Product Discontinuation Notification

PDN-22-17 PN Series Actuation force codes E and F

C&K

Build-A-Switch

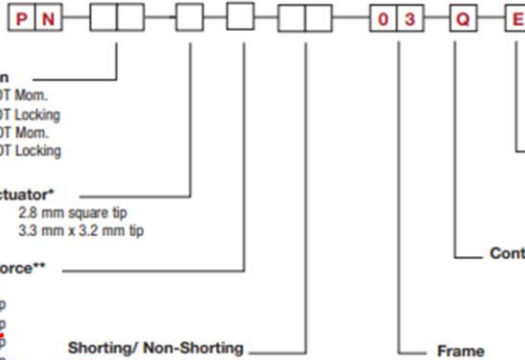
- A 50 g Typ
- B 100 g Typ
- D 180 g Typ
- ~~E 250 g Typ~~
- ~~F 100 g Typ~~
- H 250 g Typ
- J 350 g Typ

PN 11 & PN 21 available with Actuation Force "B", "D", ~~"E"~~, "H", "J"

PN 12 & PN 22 available with Actuation Force "D", ~~"E"~~, "H", "J"

To remove duplicated actuation force option code E & F. Actuation force option E is to replace by option H and actuation force option F is to replace by option B. The product is the same for both the current and replacement part, this is to remove the extra coding to avoid the confusion.
